DEVELOPMENT REVIEW COMMITTEE (DRC) COMMENT REPORT

Project Name: Madison Fort Lauderdale, LLC / Hampton Inn & Suites

Case Number: R14031

Request: Site Plan Level III Review / Marina Hotel w/
Parking Reduction

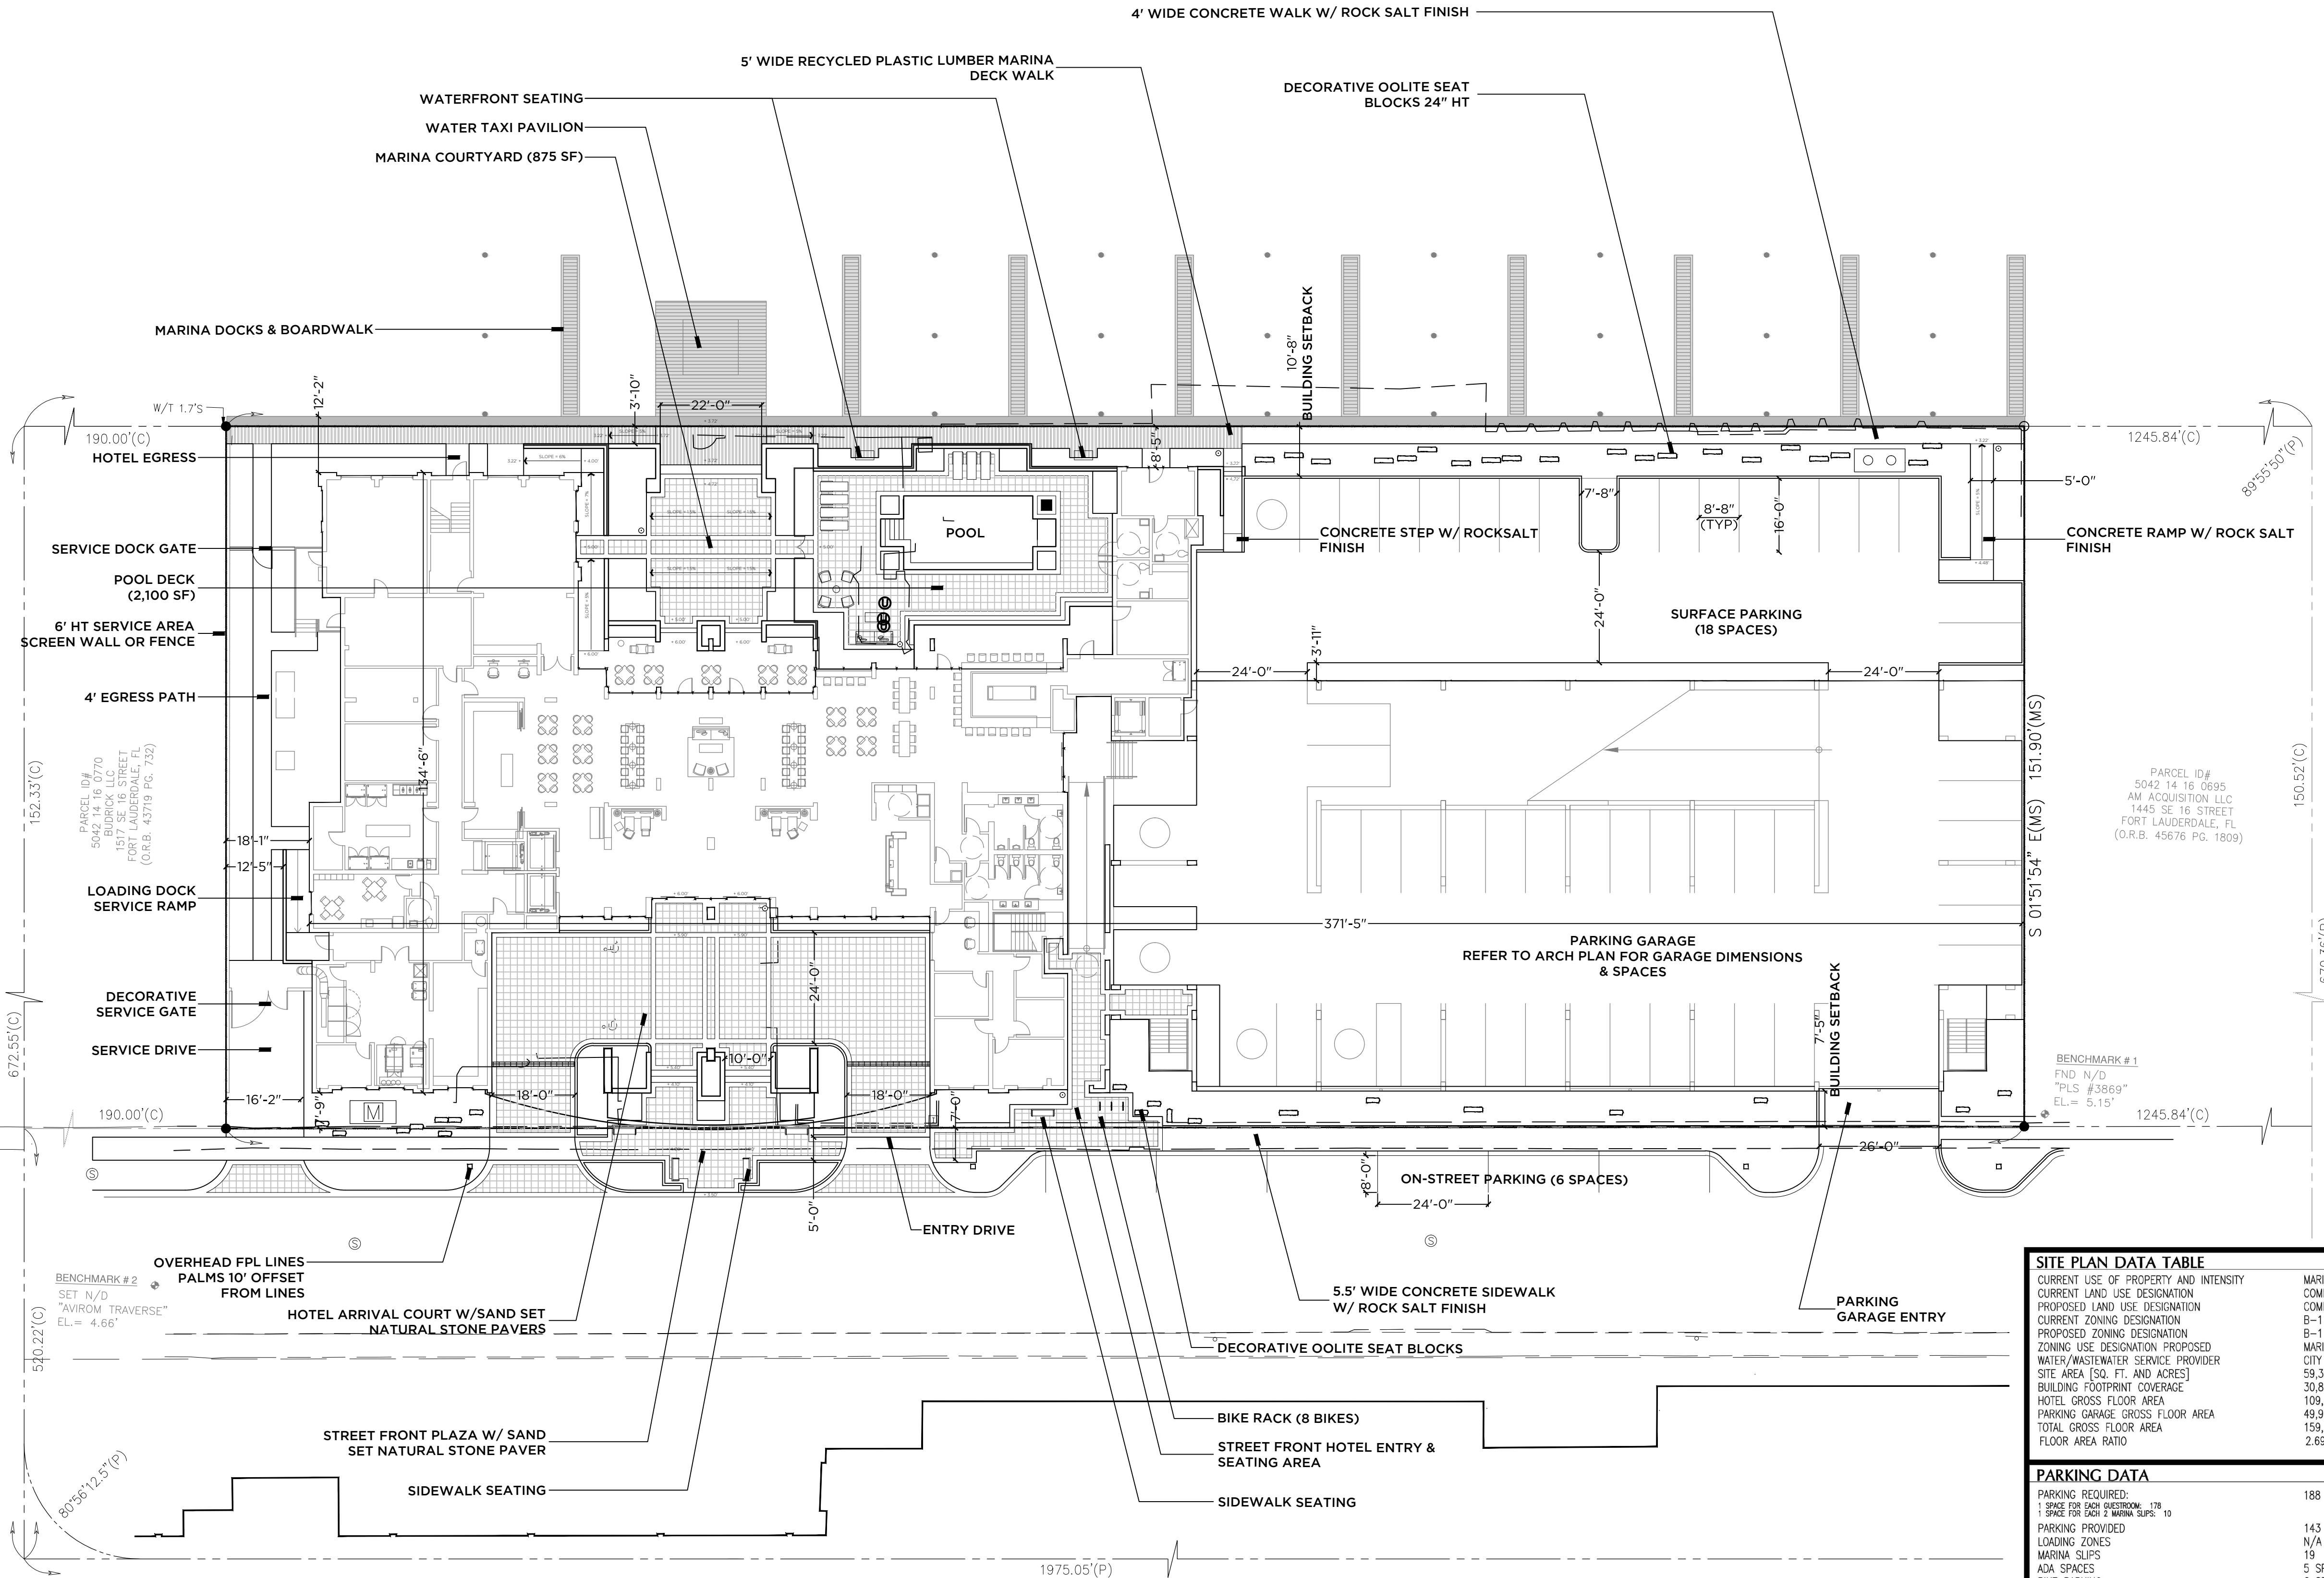
3. Show the slope of the garage ramp on the site plan.
4. Show sight triangle for the garage ingress/egress and driveways at SE 16th Street in accordance with Section 47-2.2.Q.1 of the ULDR.

5. Please discuss the purpose of the service drive. Is this area utilized for loading/unloading? If so, even though the use does not require one, the dimensions and geometric configuration of the proposed loading/unloading shall still satisfy the requirements of Section 47-20.2 of the ULDR. In addition, show typical turning template for the trucks utilizing the proposed loading/unloading area.

- 13) Provide the following changes on site plan:
 - a. Indicate all utilities (both above and below ground) that would affect the proposed footprint and landscape plan. Overhead lines should be placed underground. If the lines cannot be placed underground provide documentation from FP&L indicating such

- b. Indicate location of trash receptacles / dumpsters on site plan; discuss any anticipated recycling program to be used at the site.
 - c. Identify and label all site features.
